Jefferson Proving Ground Madison, Indiana

Draft Final Phase II Remedial Investigation

Re: Draft Final Remedial Investigation
Jefferson Proving Ground,
Madison, IN

Figure 23-l. Sampling Locations at Building 227 Former Storage Pad (Site 31)

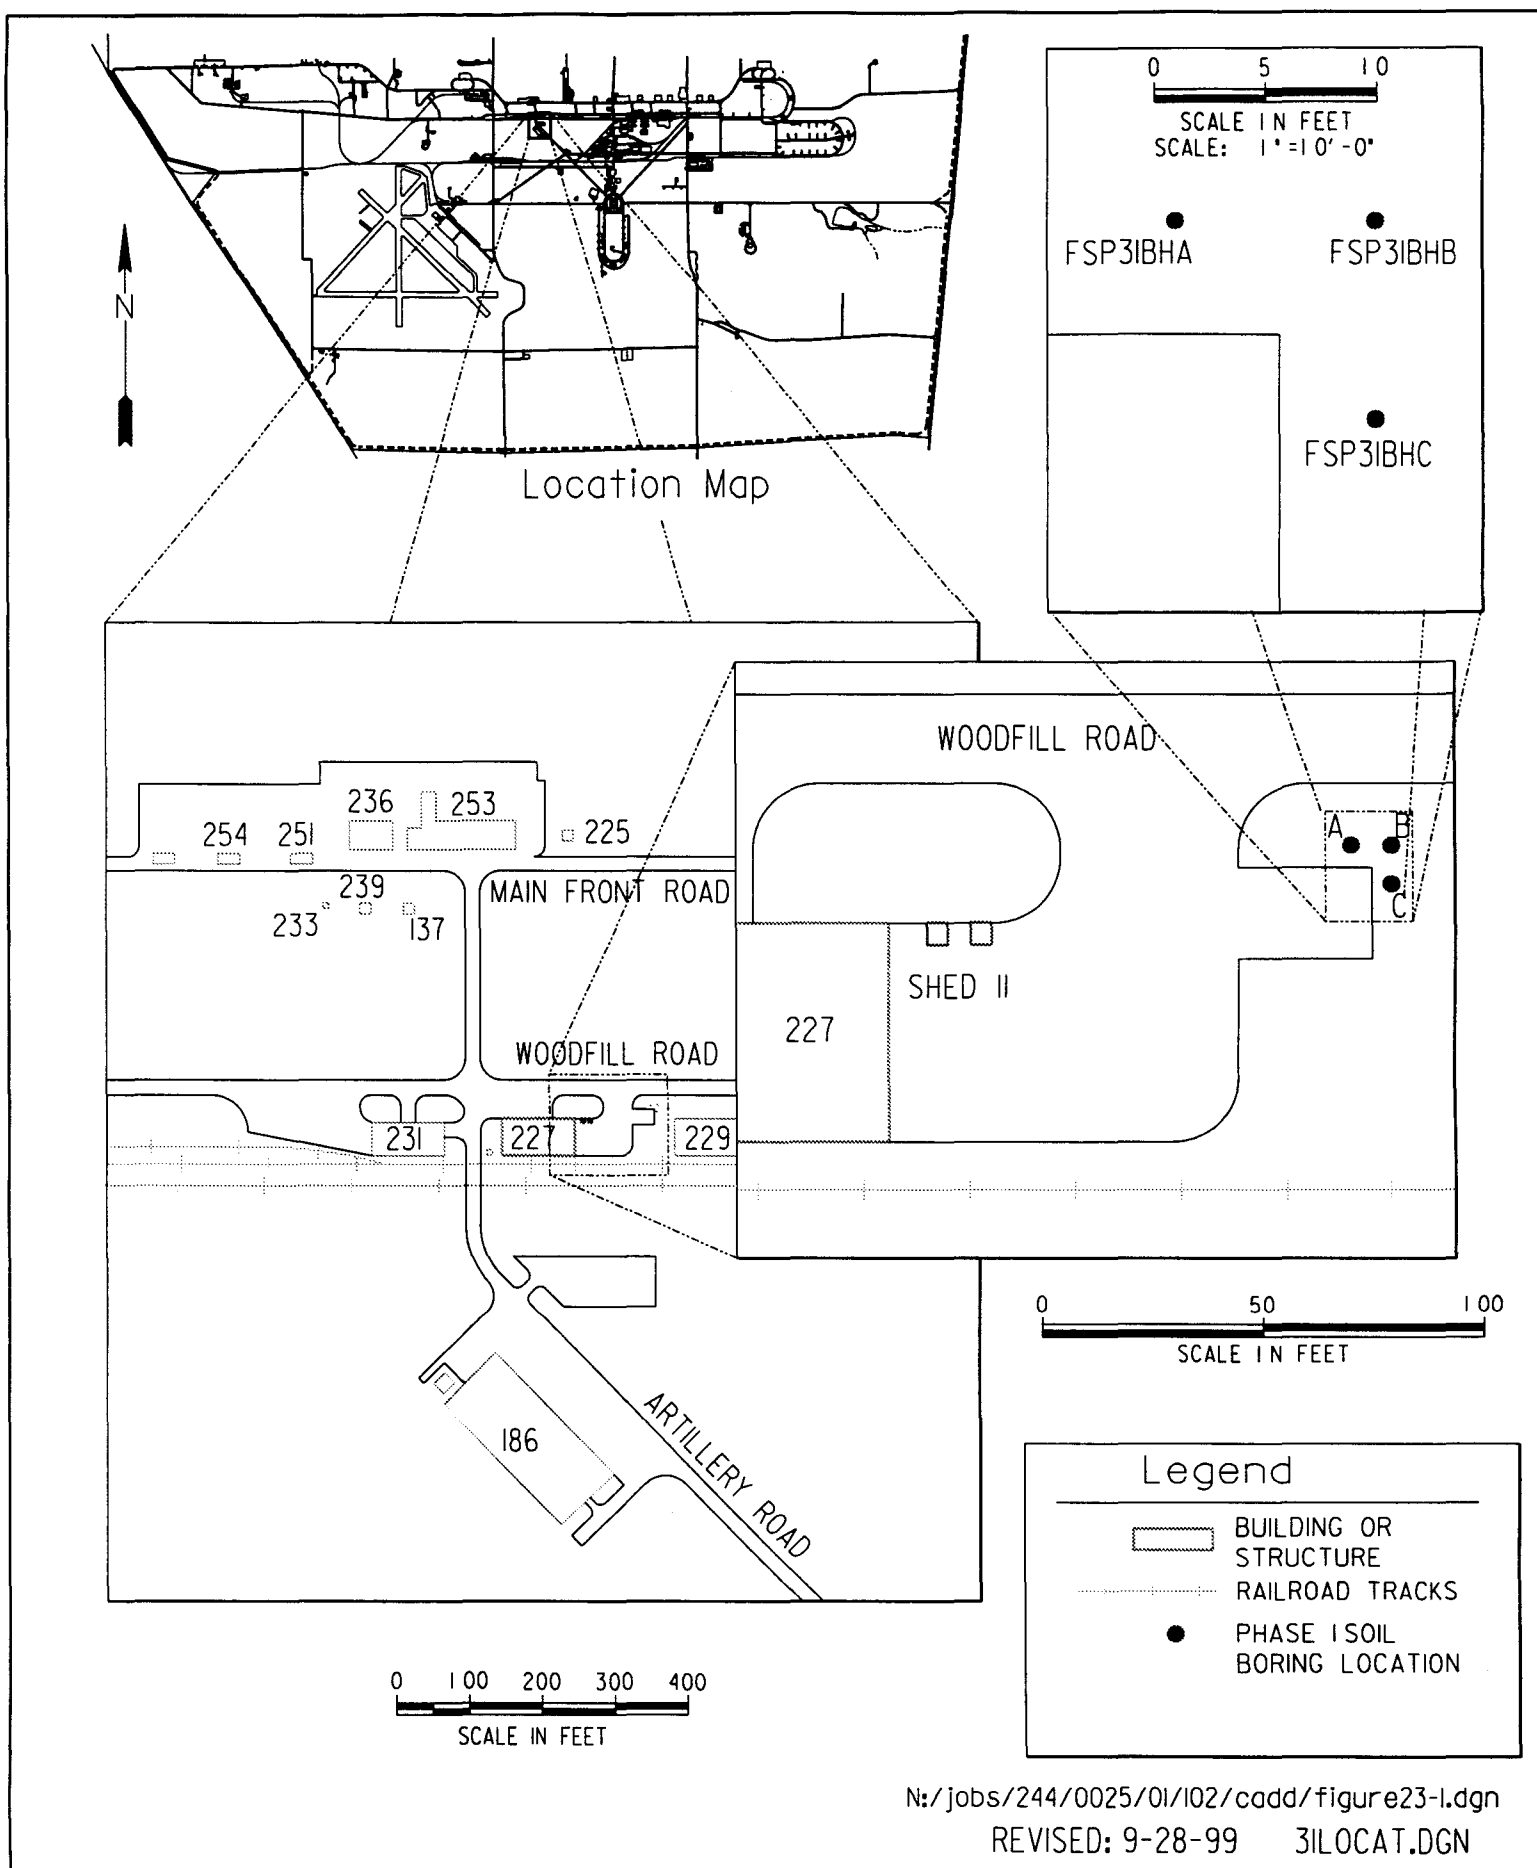
| Comment # | Section | Comment (EPA/IDEM as indicated in comment number) | Original Response to Comment (ET) | MW Revised Response (if applicable) | Agency Concur |
|-----------|---------------------|---|--|---|---------------|
| EPA58 | 23.1 Figure 23-1 | 32. Section 23.1, Site Characteristics, Page 23-1, Paragraph 1: Figure 23-1 does not indicate the location of Shed 11. Revise this figure to include Shed 11. | Shed 11 is shown in the figure but was not labeled. A label will be added. | Comments addressed per ET’s response. | |
